## Australian Institute of Architects

Better Apartments – draft  
Design Standards

**Submission to  
Victorian Dept.  
Environment, Land,  
Water and Planning**

**September 2016**

See example below for diagram of proposed room depth in larger apartments:

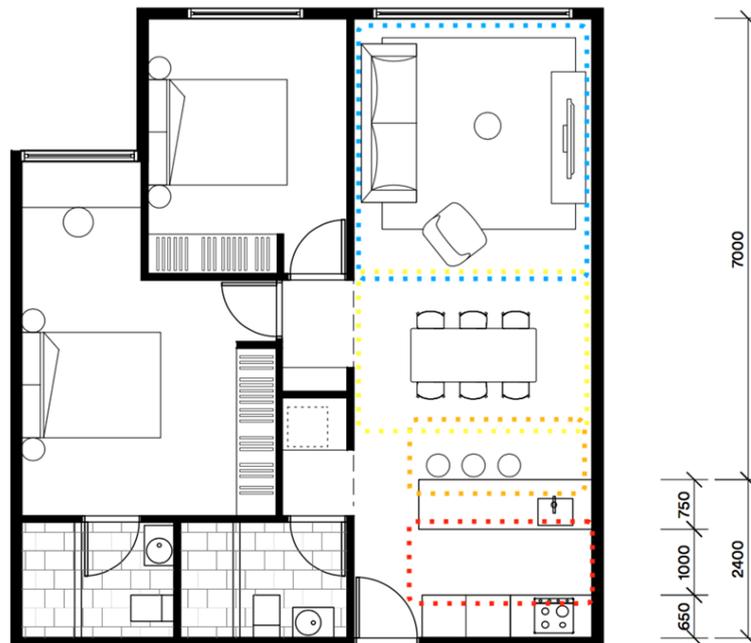
We support the introduction of a Standard that seeks to control adequacy of daylight to apartments. We propose the wording of the Standard needs to be modified and a definition of 'adequate' be provided. The Standard adopts a 'deemed to satisfy' approach without reference to the multitude of critical factors which can effect daylight. The most important of these are window sizes and glass colour, design components which have a great influence over daylight levels in an apartment.

The result of ratios being used for room depth to determine ceiling height means a minimum ceiling height of 2.4m is required for room depths up to 6m (rather than the preferred 2.7m). Better designed apartments acknowledge apartment size and layout rather than ratio as it's the whole space that makes the apartment better designed and increases liveability.

The Standard as drafted places severe restrictions on how an apartment can be planned. For example, in order to accommodate a dining table and living space in front of an island bench a dimension of 6.5 / 7m is necessary. Adding 2.5 depth for a kitchen requires a room depth of a minimum of 9.0m. The example apartment included in the Standards does not allow space for a dining table, which is a prerequisite of the vast majority of apartment purchasers of larger apartments.

It should also be noted that an adverse impact of this Standard is that some apartments would become smaller due to the pressures created by yield, frontage and room depth. We suggest that this Standard should only apply to minimum unit areas or have concessions for apartment size.

- Room Depth can be increased to 9m to accommodate a dining table when the following requirements are met:
  - Kitchen is furthest from the window
  - The window has a minimum area of  $Xm^2$  or a lux level of X is achieved in the living area
  - The ceiling is 2.7m (can be reduced to accommodate services).
- Dual aspect living rooms should have a depth of 14m when the following requirements are met:
  - Kitchen is furthest from the window
  - The window has a minimum area of  $Xm^2$  or a lux level of X is achieved in the living area
  - The ceiling is 2.7m (can be reduced to accommodate services).
- Consider rooms with more than one orientation or rooms that have secondary windows.
  - As well as the 'deemed to satisfy' option the Standard should offer an alternate,

performance based, method for achieving the objective (such as minimum lux level). We recommend that defined, understood and measurable metrics for daylight be ascribed to habitable rooms. These metrics should be carefully considered and realistic and be provided by a specialist consultant.

- Distinction should be made for different daylight provision Standards according to the use of particular habitable rooms. For example, it is widely recognised by existing best practice daylight standards that the daylight levels in a bedroom are not the same as in a living room. Lower levels of light are desirable in bedrooms. Similarly, kitchens are task orientated environments and people will invariably use lights. A percentage of the room could achieve the depth ratio.
- Higher ceiling heights should be required on ground and first floor of mixed-use apartment buildings to ensure longer term adaptability for other uses.
- Consider applying this standard to units of a minimum areas or have concessions for larger apartment sizes.
